PASSENGER CAR SERVICE LETTER

NUMBER 936

SUBJECT ENGINE OIL PUMP RELIEF VALVE
TUBE KIT FOR CORRECTION OF
HYDRAULIC VALVE TAPPET
LETDOWN - 56J GOLDENHAWK

FIG. 1

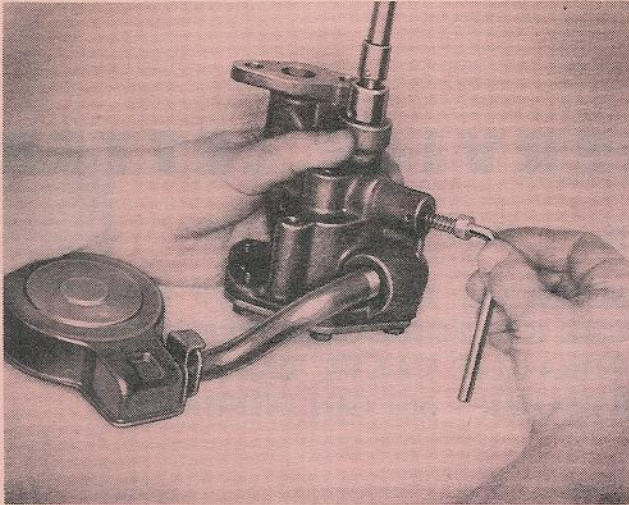
To prevent this condition, engine oil pumps for production have been revised to include a threaded plug in the open end of the bore for the oil pressure relief valve and spring. This threaded plug also acts as a retainer for the oil pressure relief valve and spring. This revision began with engine production of April 10 with the following engine numbers:

For Service, we have released an engine oil pump relief valve tube with attaching parts which can easily be installed on the oil pump in place of the relief valve spring retainer. The small end of this tube points downward into the oil in the oil pan thus preventing any air being drawn in past the relief valve. This engine oil pump pressure relief valve tube kit is identified as part number 6484613 and may be procured on order from your parts warehouse. In every case where intermittent hydraulic valve tappet noise is encountered on cars with engines before Nos. K-1638 and S-4063 this kit should be installed. Where the car has been in service less than 12 months or 12,000 miles, we will honor your claim for parts and 3.3 hours labor per car for installation.

5. Install the relief valve and spring, start the flanged end of the tube in the housing with small end of tube pointing downward. (Toward bottom of pump). (See Fig. 1).

Carefully drive the tube into the housing with the back side of flange just past the cotter pin holes. A tool can be made up locally for driving in the tube by using a small steel sleeve that will fit in the relief valve opening and cutting a slot in the side of the sleeve so it will straddle over the bend of the tube.

FIG. 2

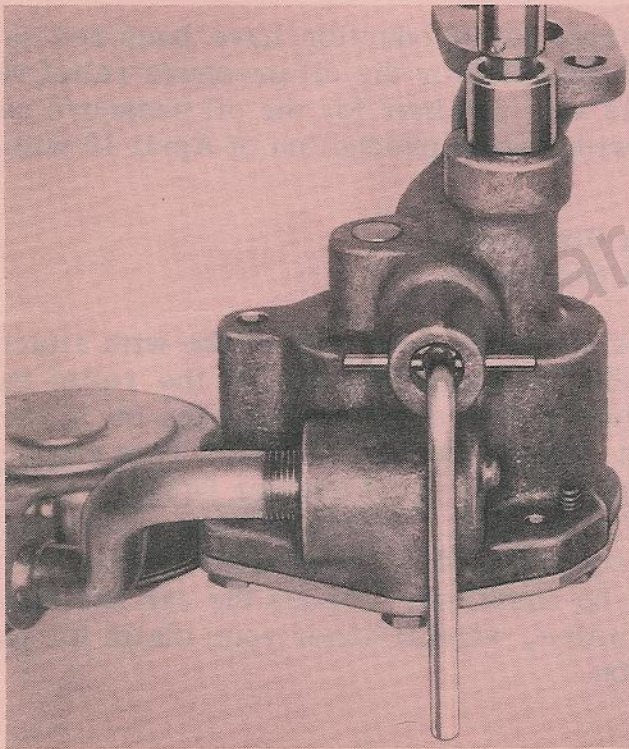
Drive a roll pin in each side of the cotter pin hole with their inner ends just touching the tube to hold it in place. (See Fig. 2).

6. If the oil pan screw holes do not line up when installing the pan, cut 1/4" off the rear roll pin with a hack saw and bend the lower end of the tube inward and forward slightly.

FIG. 3

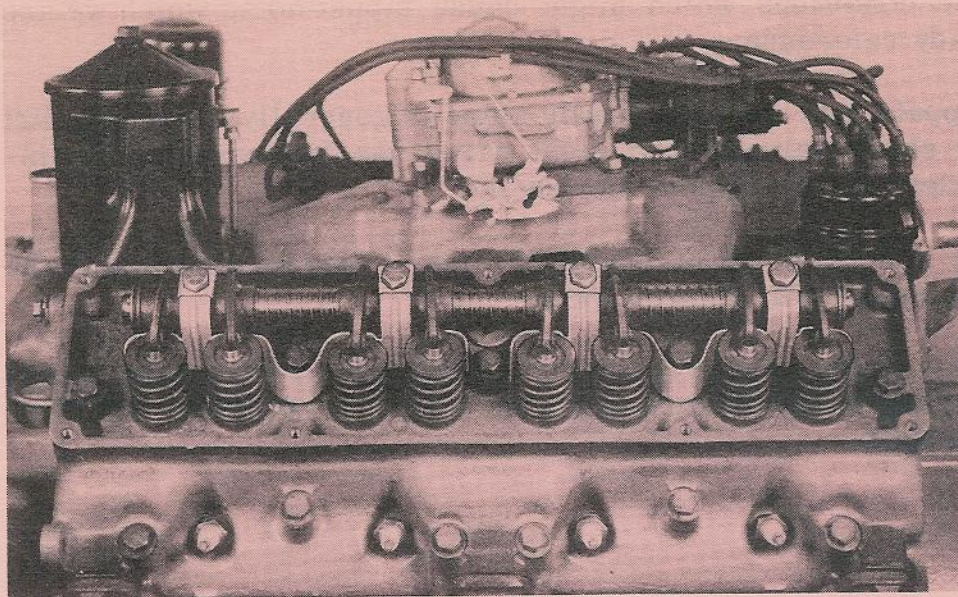
When installing the oil pump tube kit on cars with engines prior to K-1150 and S-2064, the valve spring baffle kit Part No. 6484396 should be installed. This is important for oil consumption control as noisy tappets will develop if the oil level gets too low. At the same time the possibility of oil fouling of spark plugs will be greatly reduced or eliminated.

- B. Position the baffles on rocker assembly, lining the bolt holes on baffle with bolt holes on rocker brackets. (See Fig. 3). Replace rocker assembly on cylinder head. Replace the rocker shaft bolt lockwasher with the square type lockwasher. Install the rocker shaft bolts, make sure the push rods are

in the sockets of the levers and torque tighten the rocker shaft bolts 55 to 60 ft. lbs. Be sure the square lockwashers do not turn with the bolt, as the baffles might be distorted.
